Design Review & Historic Preservation Board Meeting Agenda

Certificate of Appropriateness - Historic Property - Harris Building (PLCOA20220168)

To: Design Review and Historic Preservation Board
From: Kendall Wals, Senior Planner
RE: Harris Building Revisions, Project # PLCOA20220168
Date: January 11, 2023
Meeting Date: January 19, 2023

**PROPOSED
ELEVATIONS**

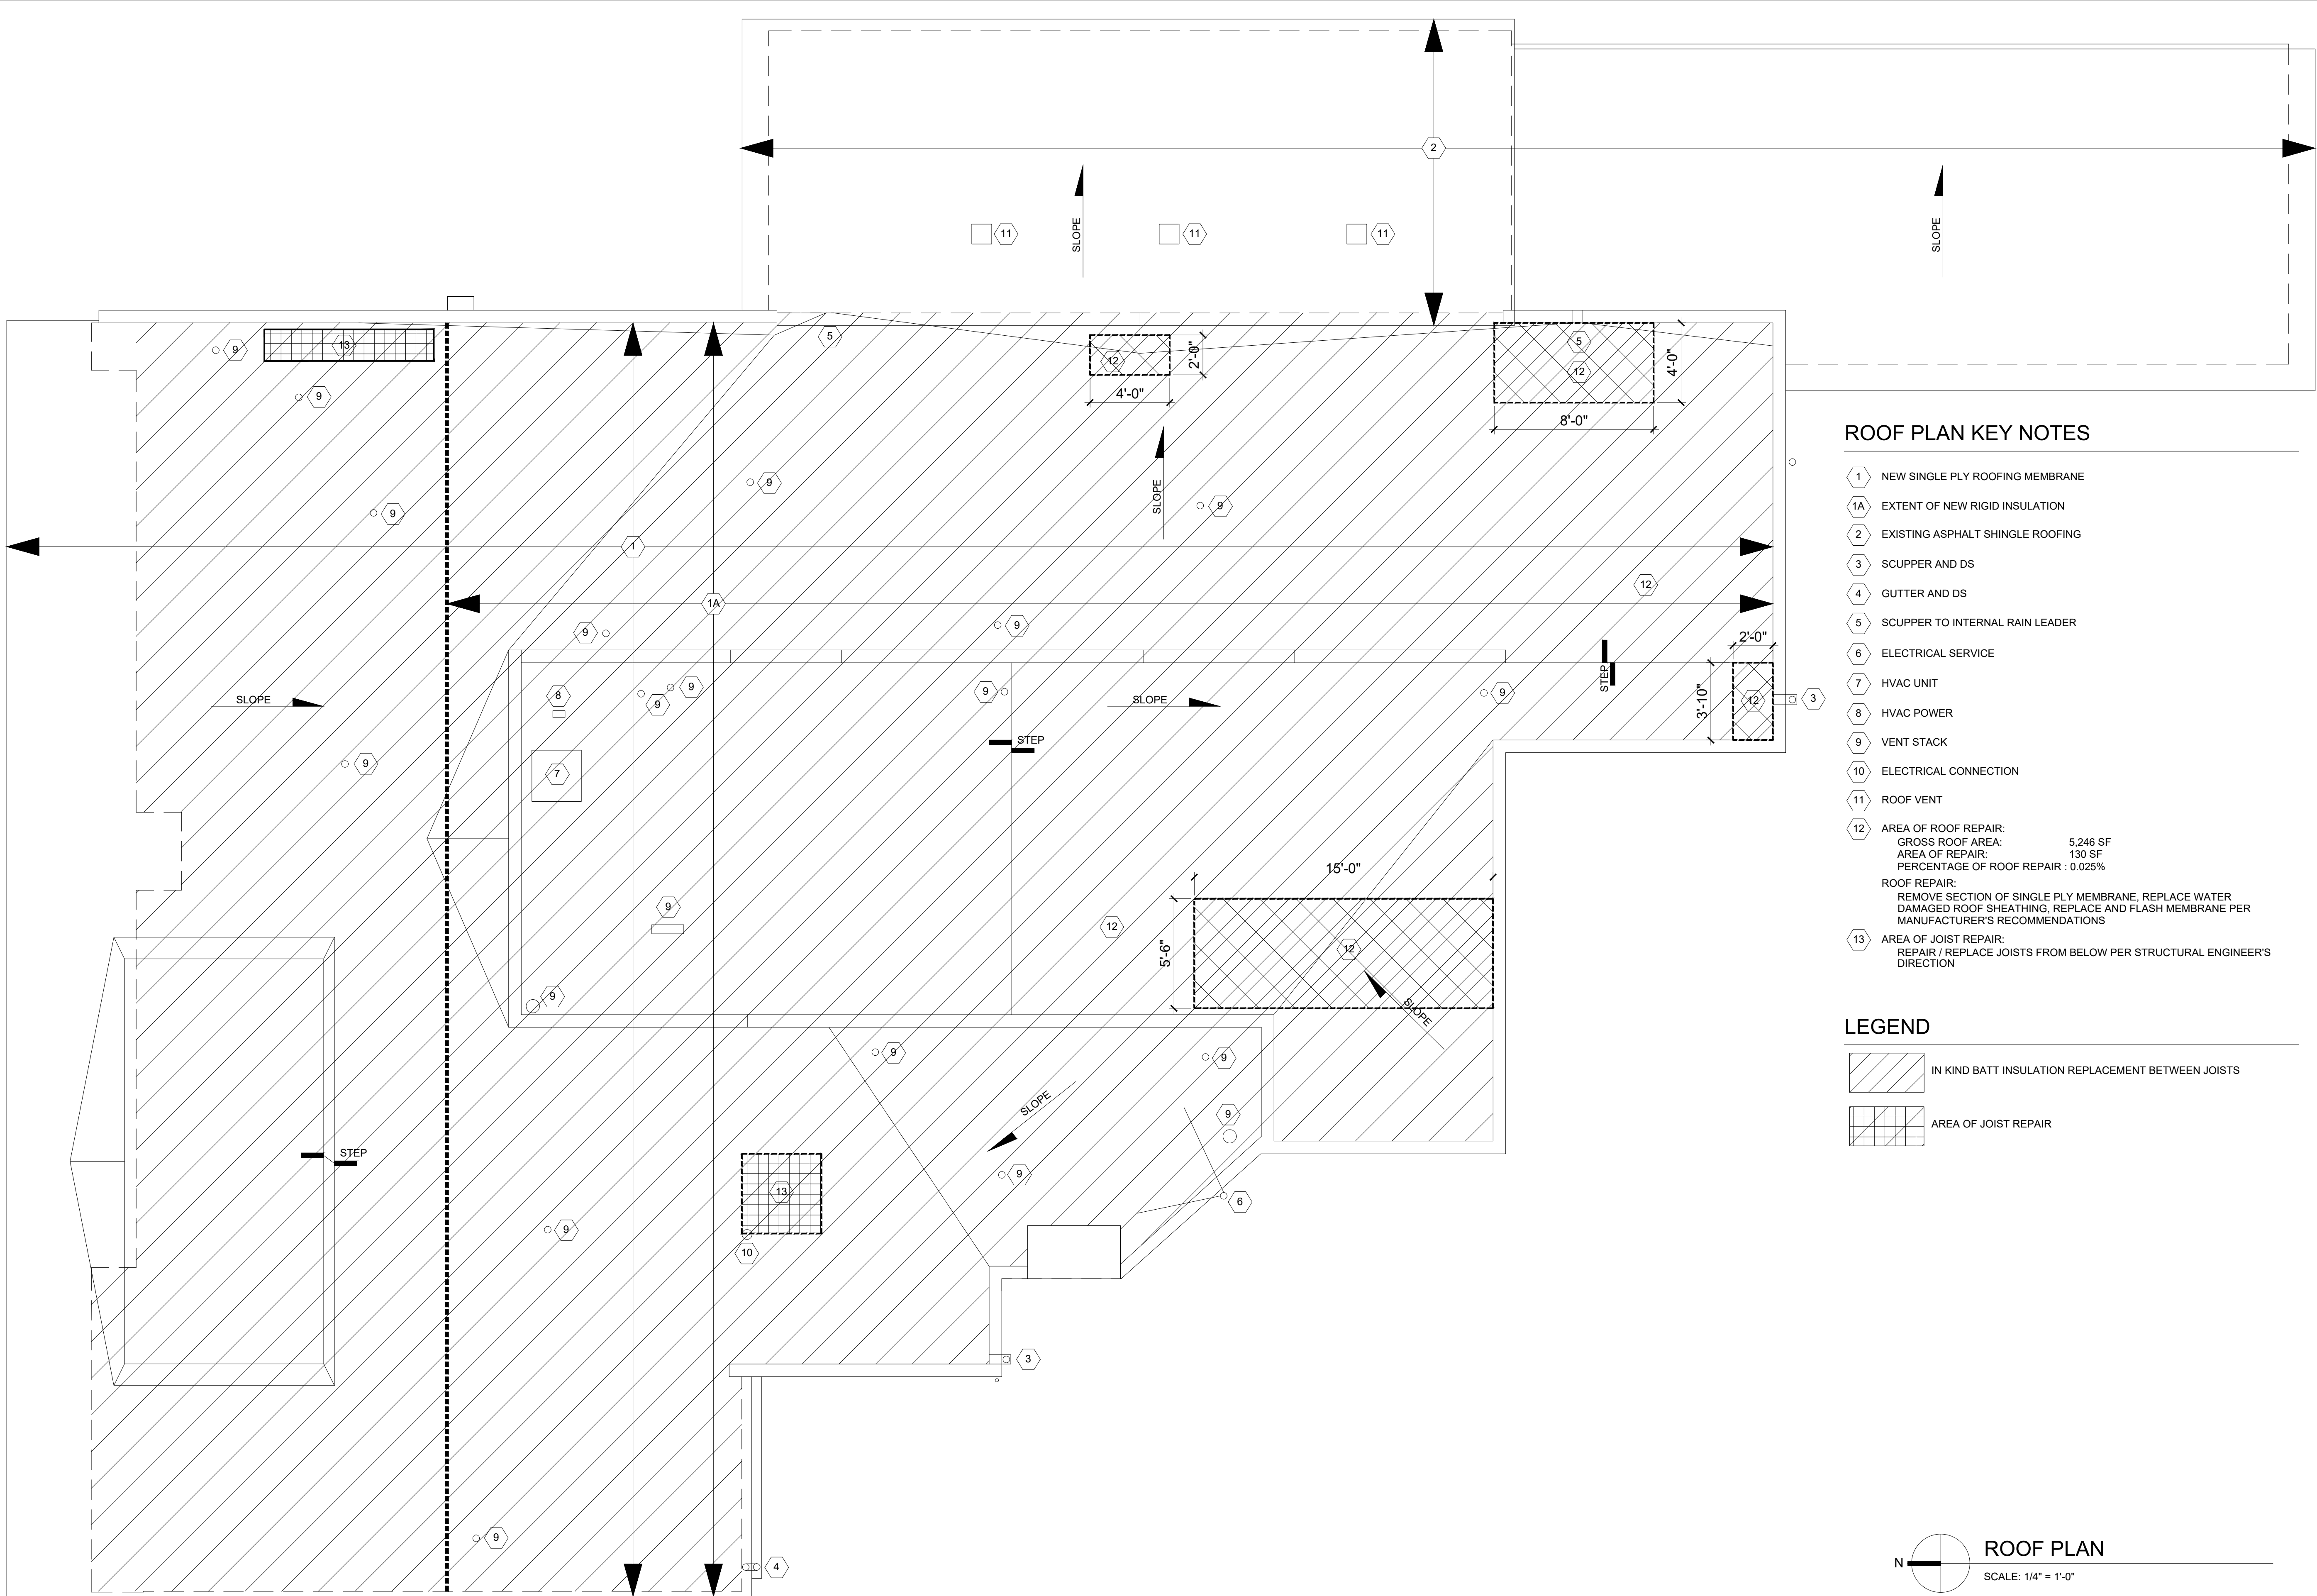
Analysis: Many of the features that are proposed to be replaced are ones that were previously modified. One of the storefront windows is proposed to be replaced "like for like" and three vinyl windows on the front façade are proposed to be replaced with anodized aluminum single hung insulated windows. In review of similar style buildings that were included in the architect's narrative with the original nomination (see attachment), the proposed replacement materials appear to be consistent with the type of architecture; however, the Board should further analyze whether the proposed window replacements meet this criterion.

Analysis: The applicant is proposing to replace T1-11 siding for a portion of the building with corrugated metal. In general, staff finds that the proposed changes are consistent with this criterion; however, the Board should consider whether the proposed material is compatible and consistent with this criterion.
